HISTORIC AND DESIGN REVIEW COMMISSION

June 06, 2018

HDRC CASE NO: 2018-268
ADDRESS: 436 DEVINE ST
LEGAL DESCRIPTION: NCB 2958 BLK 2 LOT 44
ZONING: RM-4, H
CITY COUNCIL DIST.: 1
DISTRICT: Lavaca Historic District
APPLICANT: William Massey
OWNER: Janie Barrera/Alma Del Rio
TYPE OF WORK: Window replacement, trim replacement, column installation, skirting, and paint
APPLICATION RECEIVED: May 22, 2018
60-DAY REVIEW: July 21, 2018
REQUEST:

EAST & WEST ELEVATIONS

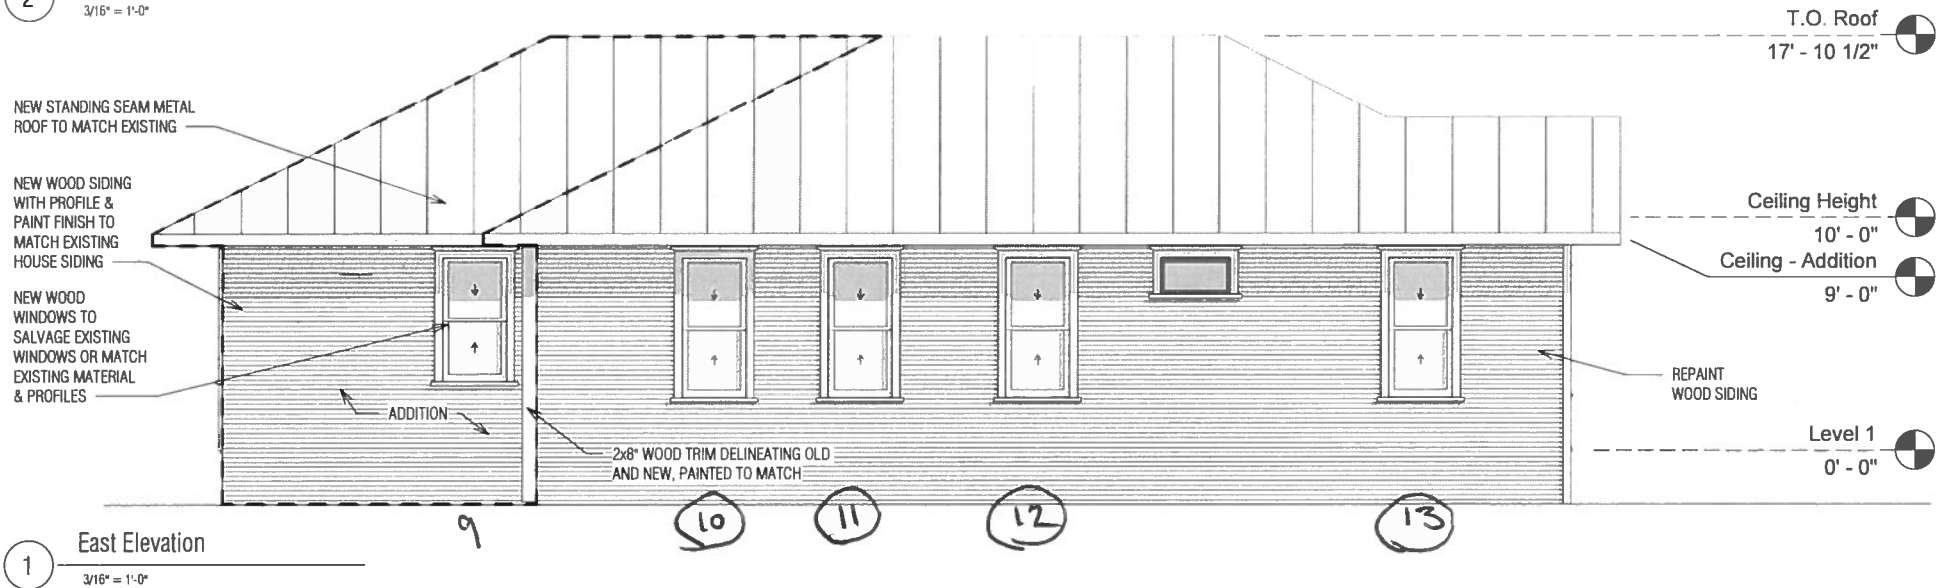
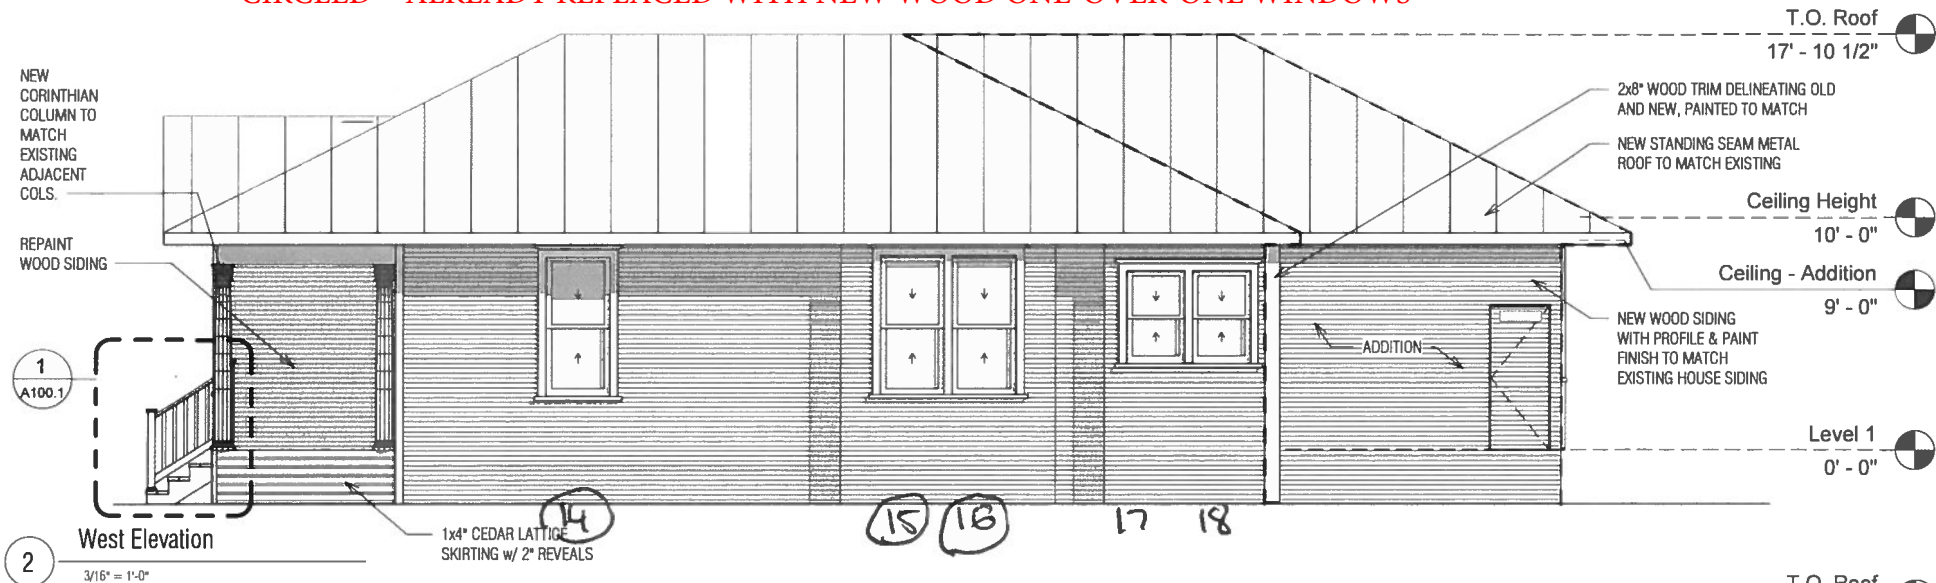
- c. WINDOW REPLACEMENT – The applicant has proposed to replace all 18 wood one-over-one windows with in-kind wood windows. 15 windows were replaced prior to approval with 3 windows remaining on site. While staff finds the replacement windows appropriate, the Guidelines state that replacement should only be considered when the window is deteriorated beyond repair. Staff finds that the remaining three (3) windows are deteriorated beyond repair and that the proposed wood one-over-one wood windows would be an appropriate replacement.

CIRCLED = ALREADY REPLACED WITH NEW WOOD ONE-OVER-ONE WINDOWS

Staff recommends approval of items 1 through 4 based on finding b through f with the that the replacement windows are consistent with the Guidelines: Meeting rails must be no taller than 1.25” and stiles no wider than 2.25”. There should be a minimum of two inches in depth between the front face of the window trim and the front face of the top window sash. This must be accomplished by recessing the window sufficiently within the opening. Window trim must feature traditional dimensions and architecturally appropriate sill detail. Window track components must be painted to match the window trim or concealed by a wood window screen set within the opening.

EVIDENCE OF MISSING COLUMN

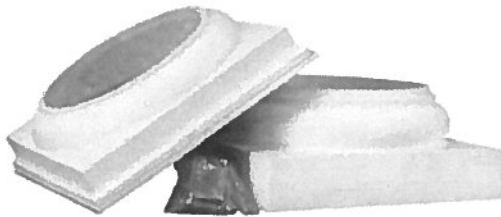
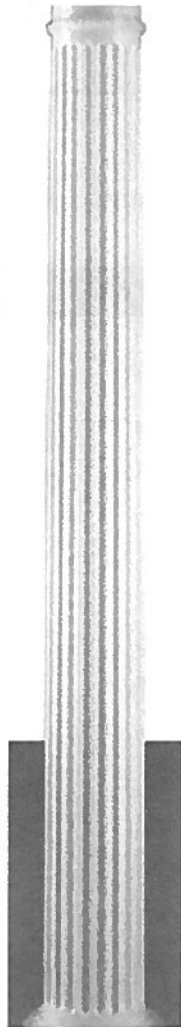
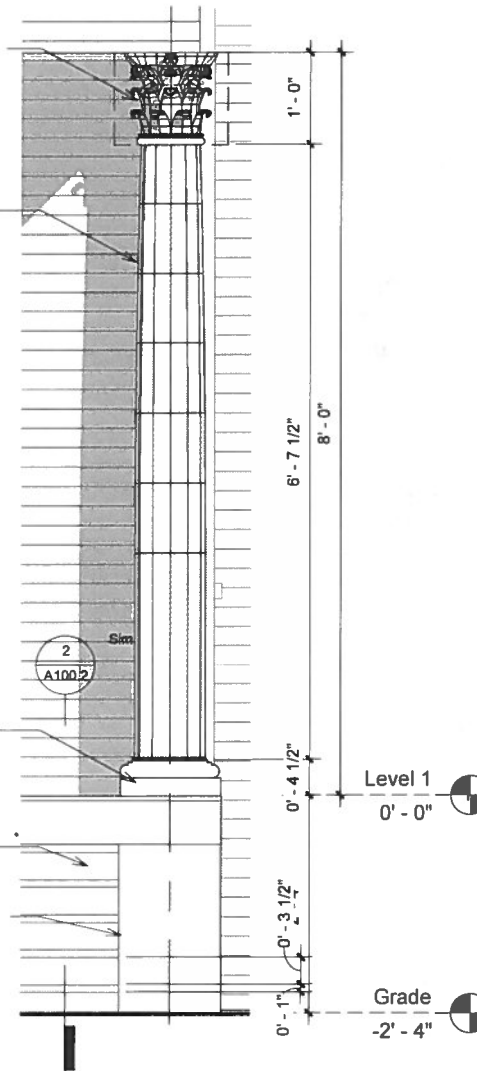
- e. COLUMN – The applicant has proposed to install an additional Corinthian column on the front porch. The applicant has provided evidence that a column had been installed and staff concurred that the missing column location is typical to front porch configurations of architectural style and period of construction. Staff finds the proposed design and location appropriate.
